MP 07-0006 – KENDALL BAY MARINA

OPPOSING SUBMISSION

**OPPOSING SUBMISSION LODGED BY THE BREAKFAST POINT RESIDENTS GROUP INC. TO MP07-0006
November 2010**

Sheet 9, DP 270347 showing the precursor of Lot 55 as Part Lot 1 and Part Lot 3

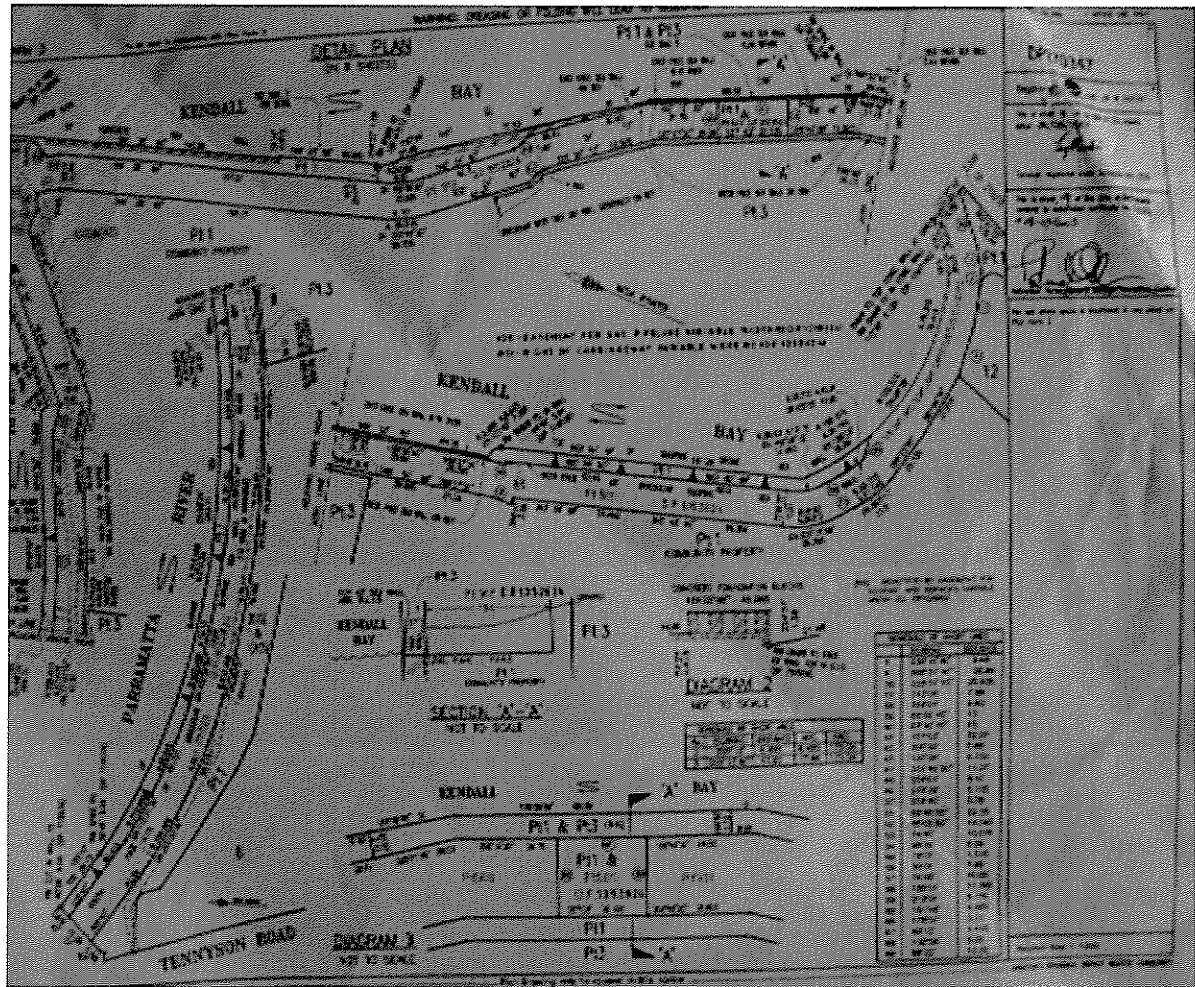
Lot 55 has a mysterious history. Sheet 9 of DP 270347 is dated 6.06.2003 and describes the same area as Pt lot 1 and Pt lot 3. There is a note on sheet 10 of DP 270347 (dated 18.07.2003) which describes these part lots as stratum lots limited in height and depth (Attachment 4). Part lot 1 is community property and lot pt 3 is part of Hunters Wharf strata property. Sheet 3 of DP 270347 is dated 29.03.2005 (Attachment 5) and this describes this same area part lots Pt lot 41. Later this part lot 41 changed to lot 55 (Attachment 6 is sheet 2 DP 270347 of 21.07.2005). The mysterious aspect of this lot is that it went from being part of a lot that was community property (Pt lot 1) and part of a lot that was strata property (Pt lot 3) to being a lot (lot 55) that is in private hands in circumstances where the *Community Land Development Act s 31 (1)* provides that, "On registration of the plan or dealing by which it is created, association property vests in the relevant association".

41 The lot had at least two previous lot numbers before becoming lot 55 on 9.09. 2005 (see sheet 9 of DP No 270347).

Sheet 3 DP 270347 showing lot PT 41 and "A"-A diagram where Pt lot 1 and Pt lot 3 were previously shown (top of picture).

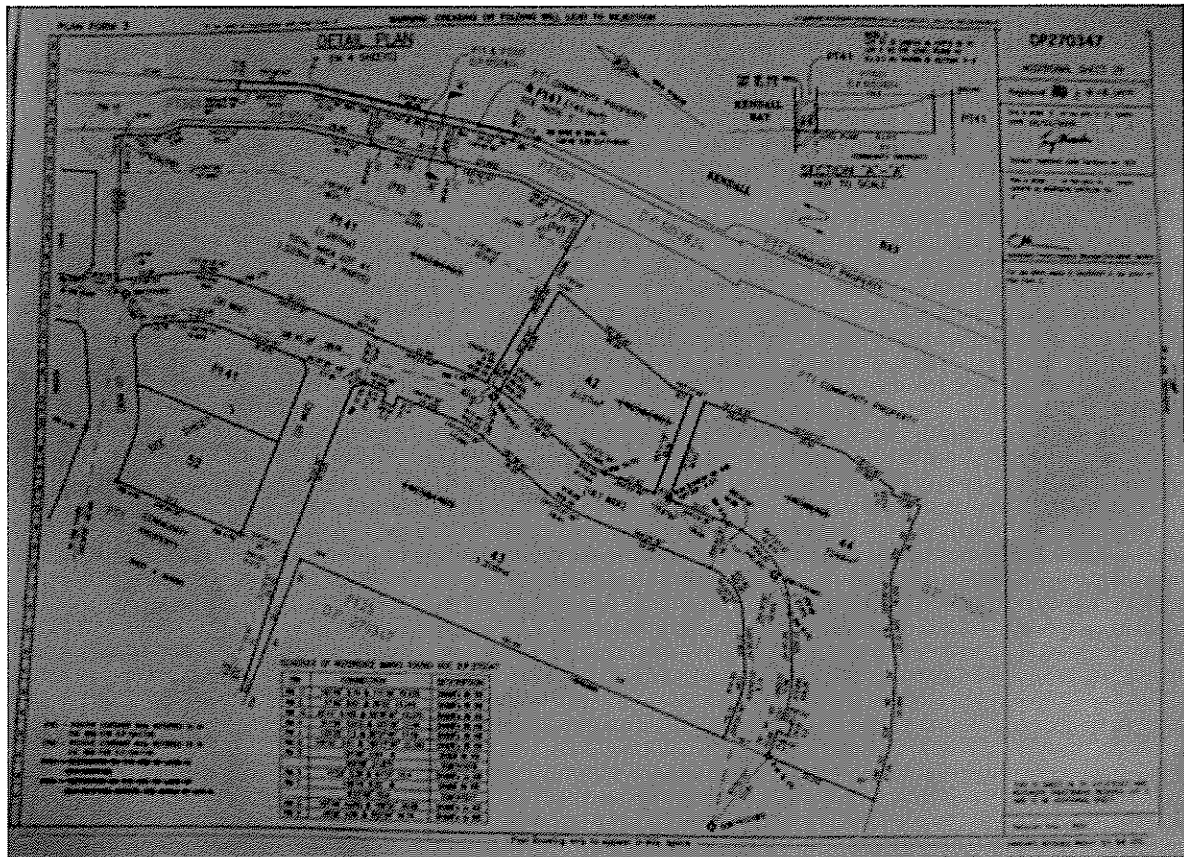
For abundance caution it is mentioned that lot 55, in its precursor existence as lot Part lot 1 and Part lot 3, is shown as being subject to an "easement for support & attachment" (see Attachment 3 which is sheet 12 DP 270347) and the s 88B schedule item 9 provides that lot 3 is benefited by such an easement while lot 1 is burdened by it⁵¹. The thing to note about this is that the "easement for support and attachment" has both the servient and the dominant lots within DP 270347. Consequently, the proposed marina structure cannot rely on this easement for "support" and "attachment". Whatever easements rights are claimed for lot 55 (or any other lot for that matter) they are only relevant so long as they are,

Sheet 2 DP 270347 showing lot 55 where previously Pt lot 1 and Pt lot 3 and later Pt lot 41 appeared. See note on "A"- "A" diagram.

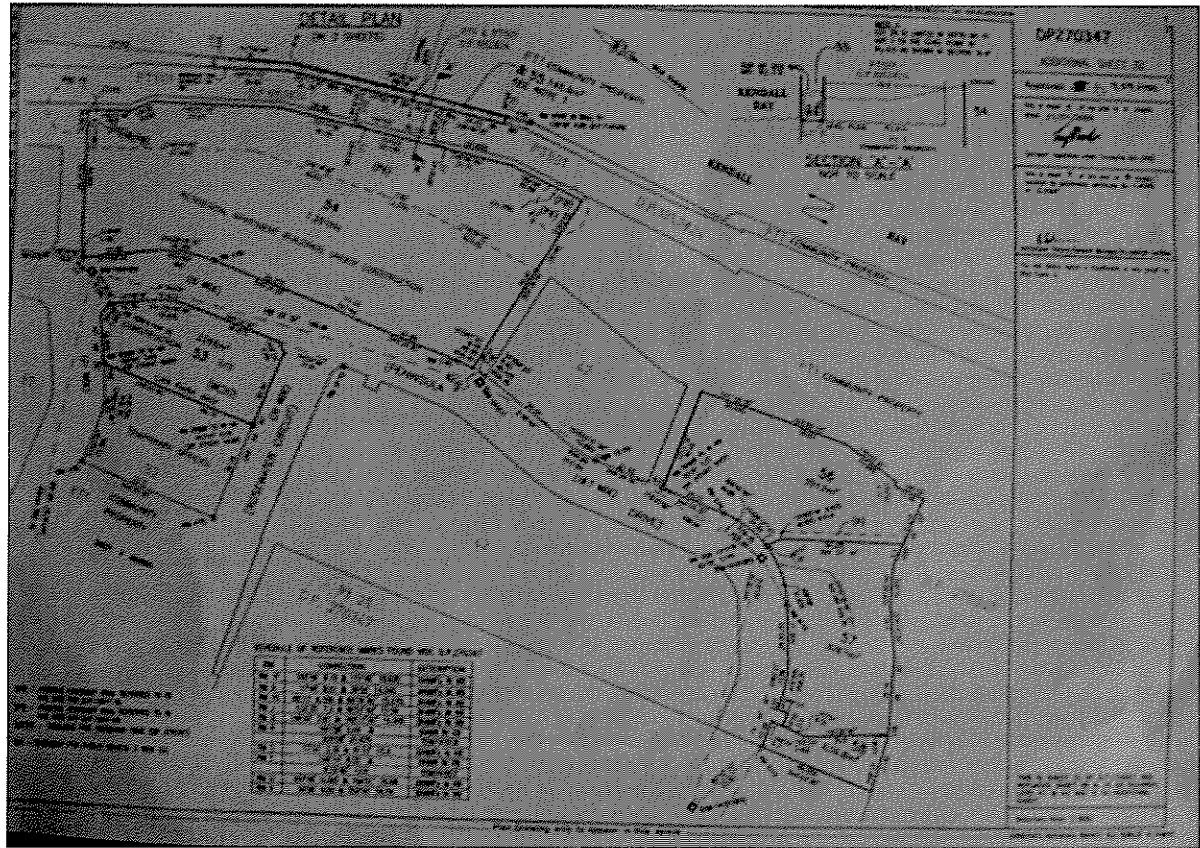
For most of its length the seawall is part lot 1 DP 270347. For part of its length (in front of Hunters Wharf), a part of it limited in depth and length is identified as lot 55 DP No 270347⁴¹. Lot 55 is in the name of the developer.⁴² It is at lot 55 the proposed commercial marina joins up with the *Community Association* parcel (see Attachment 2 being sheet 9 DP 270347 and Note 1 and the "A"- "A" diagram). Interpreting the diagram and notation is not easy but it seems that the area below the seawall and the part of the seawall below the level plane at R.L. 0.5 is still part lot 1 DP 270347. *This "A"- "A" diagram and the notations on it show that the R.L. to the top of the seawall is 1.5 but lot 55 is limited to an R.L. of 0.5 which means that there is still a section of the seawall that is above lot 55 that is Community Association property. Support for this interpretation can be found in the MPA documentation at 5.6 where it says,*

From seawall. Hunters Wharf. Walkway in foreground. The fence/and hedge in the background is strata property. The community association property is a strip 1m wide from this fence going towards the walkway and from that point to the seawall is 15m wide.

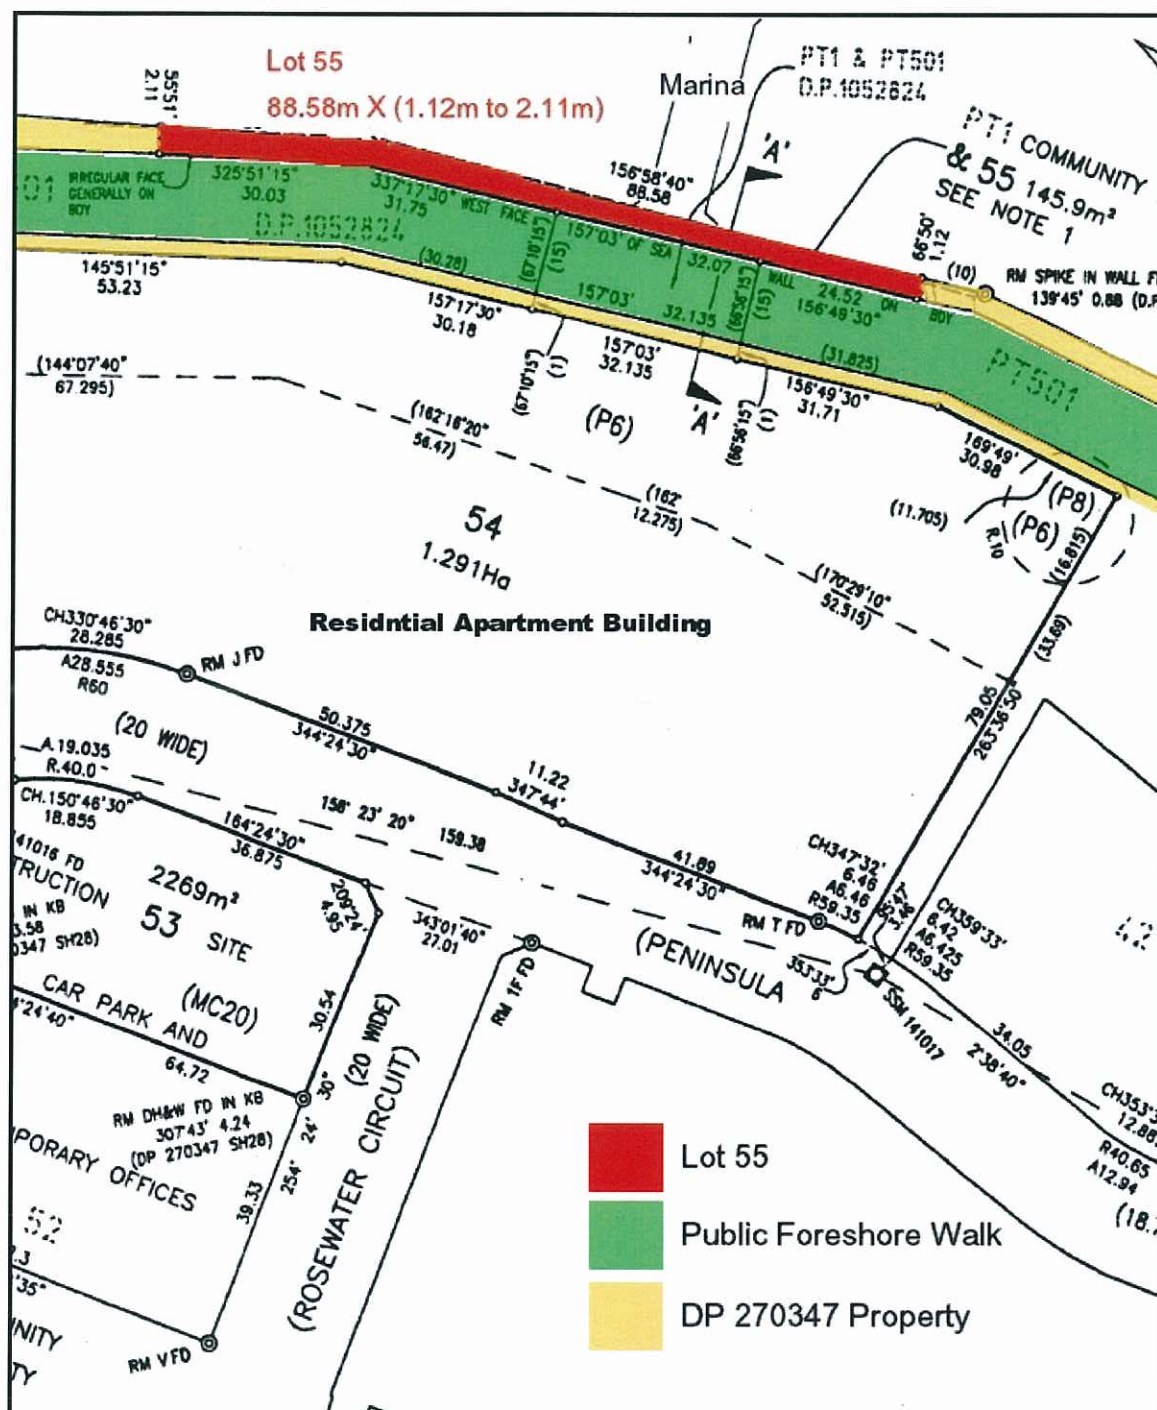
Note the shape and width of Lot 55 to which the marina is to be attached (connected). Note its proximity to the Public Foreshore Walkway.
